305 S. Congress PUD

Presentation
to the
Parks and Recreation Board
August 5, 2021

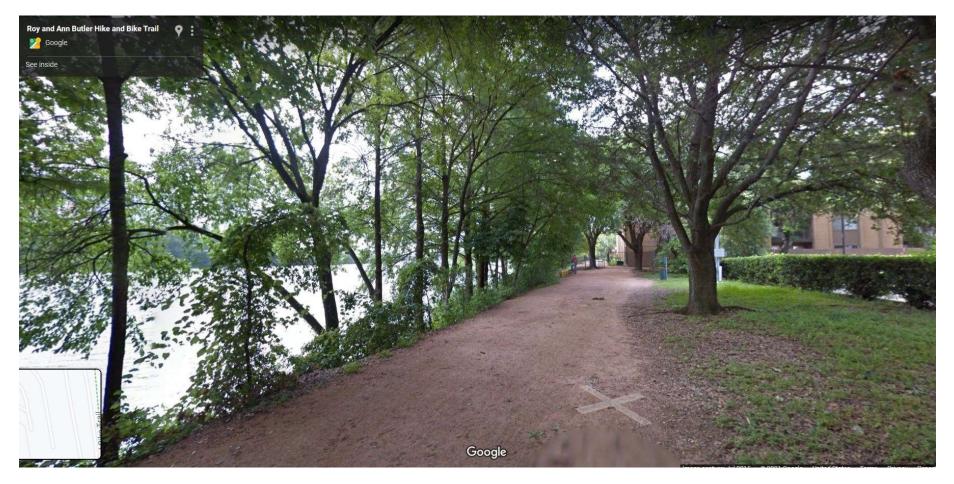
There are areas on the west side of the property that are more suited to programming. This area near Congress bridge is full of ragweed and has no trees, it is where shoreline access including the pier and stairs should be located.

There are areas throughout the shoreline that are eroding and need to be restored and protected with a split rail fence.

There are areas along the trail where water is running downhill across the trail and causing erosion along the shoreline.

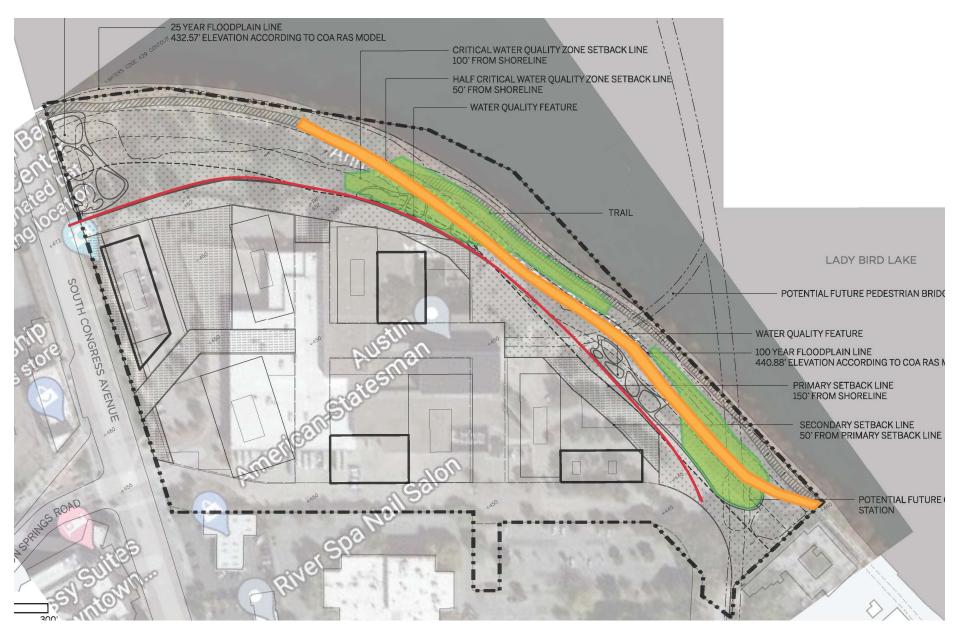
On the eastern half of the property, the trail lies on the edge of the shoreline and is causing erosion downslope. Staff suggests that the trail be moved a minimum of 25' from the shoreline in these areas. The area between the trail and the shoreline should be restored.

In exchange for denser development on the west side for bat viewing, staff proposes moving the trail off the shoreline as shown. Staff also proposes moving all water quality ponds as shown and integrating the rain gardens with restoration, alleviating the need for a deep biofiltration pond in the bat viewing area.
